# METROPOLITAN GOVERNMENT OF NASHVILLE AND DAVIDSON COUNTY

Metropolitan Historic Zoning Commission  
Sunnyside in Sevier Park  
3000 Granny White Pike  
Nashville, Tennessee 37204  
Telephone: (615) 862-7970  
Fax: (615) 862-7974

## STAFF RECOMMENDATION 4204 Elkins Avenue September 19, 2012

**Application:** New construction - addition  
**District:** Park and Elkins Neighborhood Conservation Zoning Overlay  
**Council District:** 24  
**Map and Parcel Number:** 09116019900  
**Applicant:** Jerry Earwood, Nashville Rehabbers  
**Project Lead:** Sean Alexander, sean.alexander@nashville.gov

Left Side Elevation  
-Right Side Similar

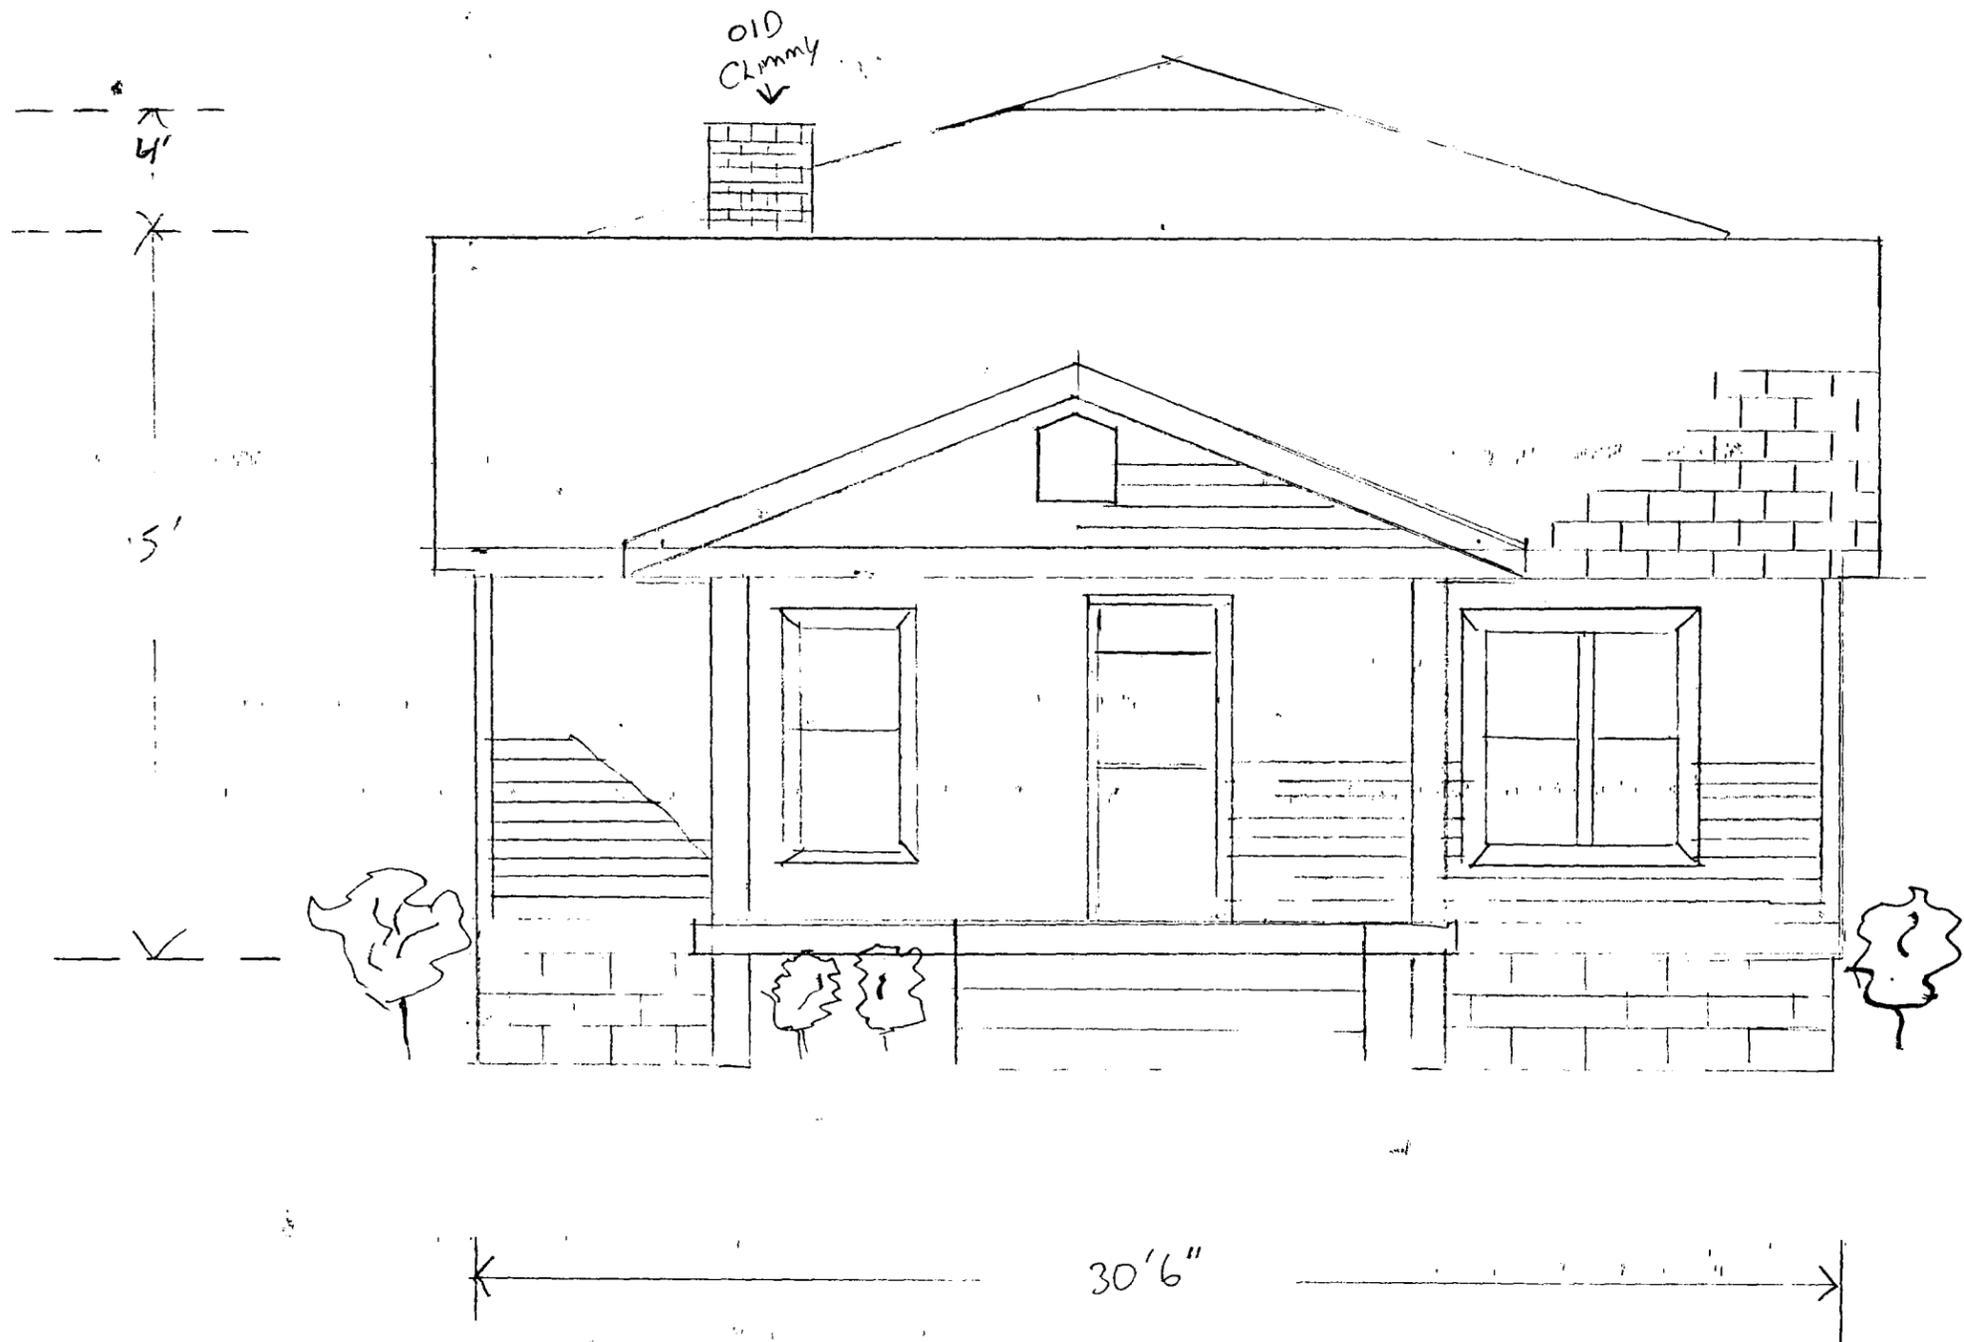
The existing rear addition is not original, and will be removed. The new addition will have a two-story massing, four feet narrower than the existing house but also (4') taller. The taller roof of the addition will not be greatly visible because it occurs forty feet (40') behind the front of the existing house. Additionally, the massing will be largely obscured because the addition will be set in from the sides of the existing house by a hyphen that sets in three feet (3') and eighteen inches (18") below the existing roof. These proportions are compatible with the existing house and meet guideline II.B.1.a. and II.B.1.b.

The primary component of the addition, the nearly square two-story element, will have a cross-gabled roof with a 6:12 pitch on the left-to-right ridge, and a 3:12 pitch on the front-to-back ridge. The 6:12 pitch roof only will be minimally visible because the addition sets in and will be obscured by the existing side-gabled roof therefore staff finds that the roofs will meet guideline II.B.1.e.

The addition will have evenly spaced windows on both stories on both sides, and the windows will be taller on the first story than the second. These window openings meet guideline II.B.1.g.

**Recommendation:** Staff recommends approval of the proposed addition to 4204 Elkins Avenue, with the condition that staff approve the specific window selections prior to purchase, finding it to meet the design guidelines for the Park and Elkins Neighborhood Conservation Zoning overlay.

Rear Elevation

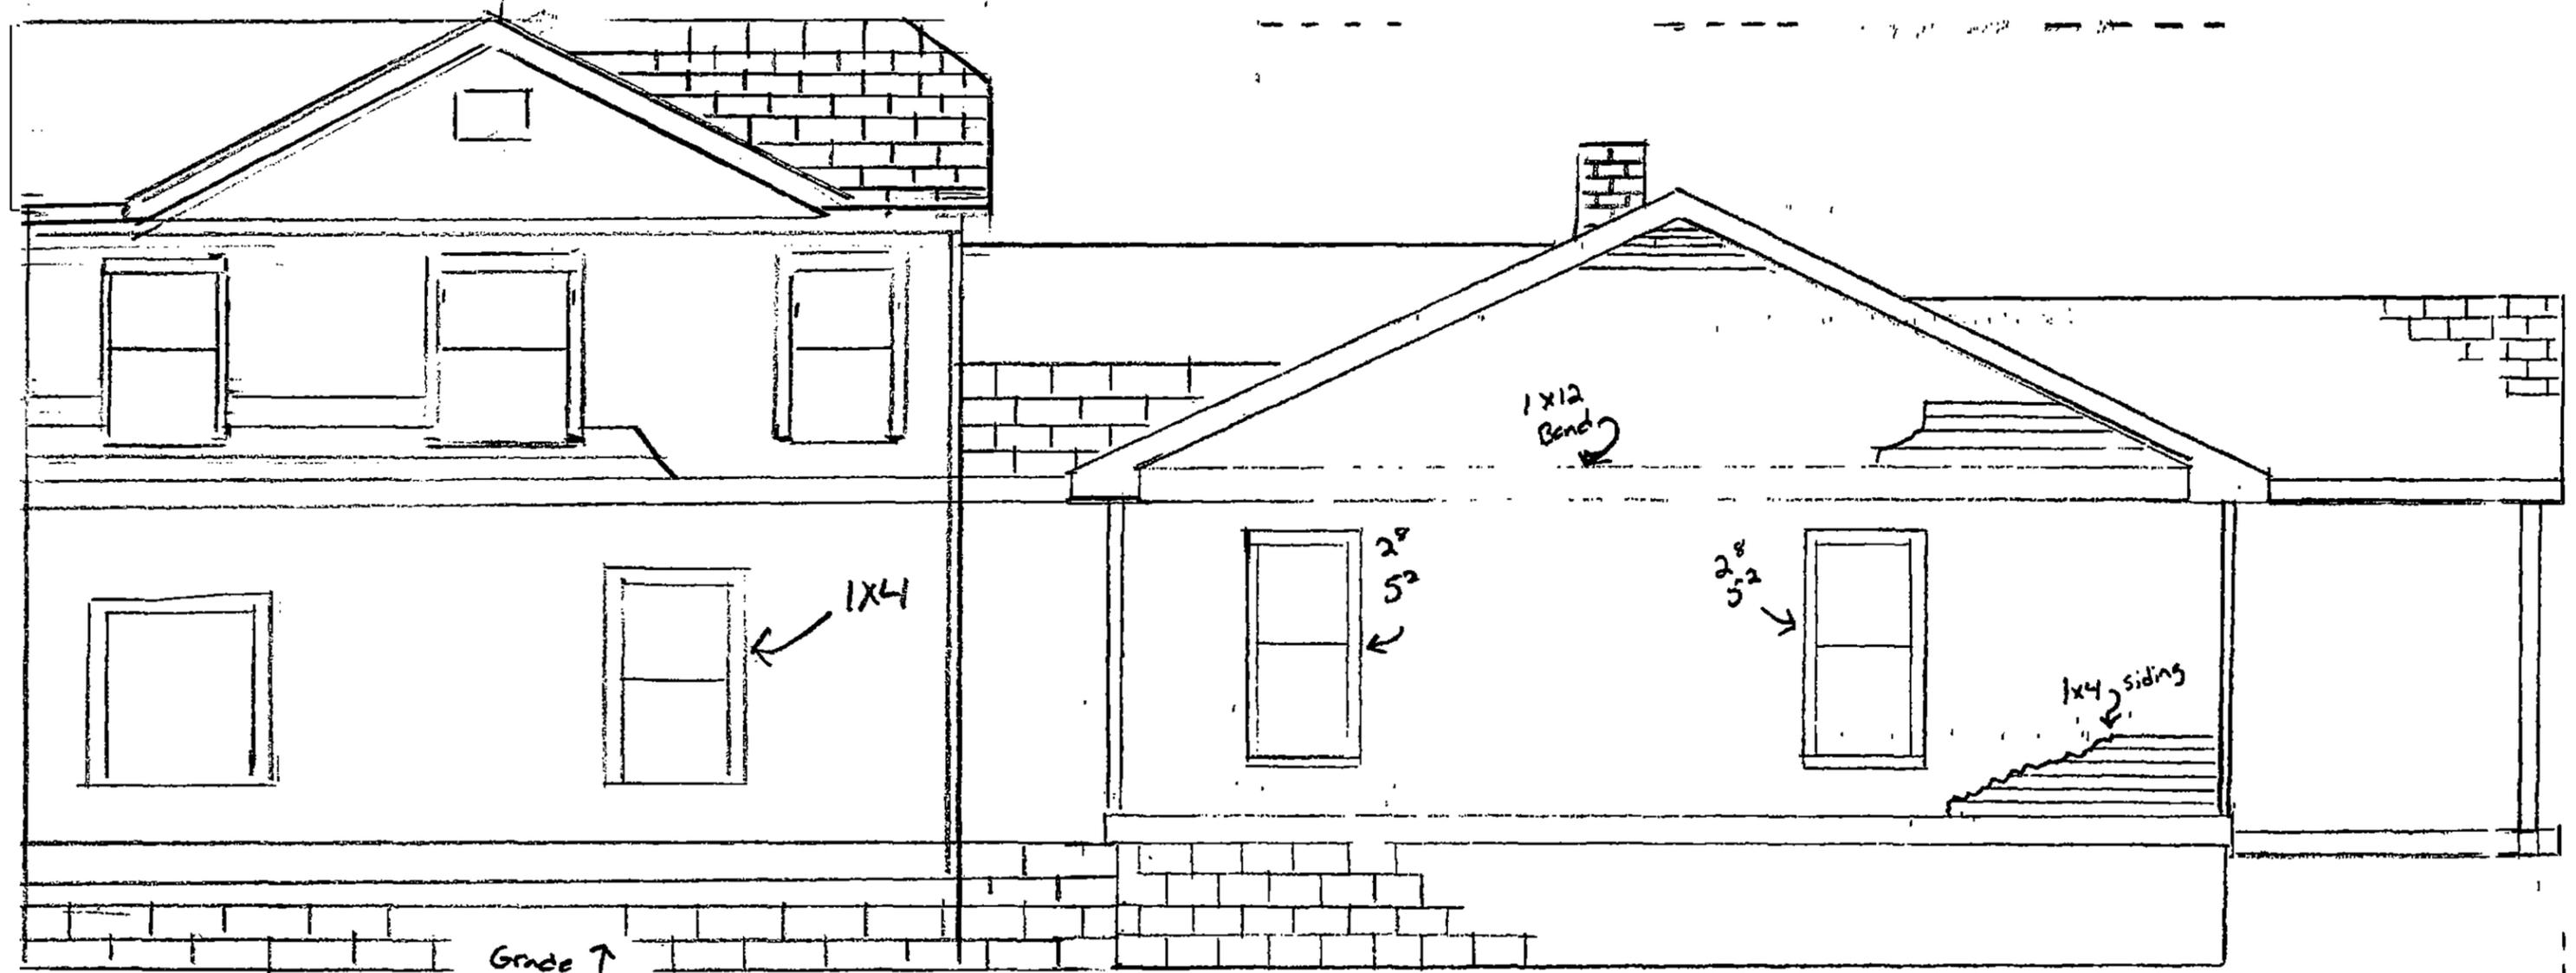
The materials of the addition will include: smooth-faced cement-fiber siding with a five inch (5") reveal, split-faced concrete block foundation, and a fiberglass shingle roof

matching the color of the existing roof. The windows and trim will be wood. The existing vinyl siding and vinyl windows will also be replaced. Additional information on the new windows is needed to determine compliance with the design guidelines, but in general these materials meet guideline II.B.1.d.
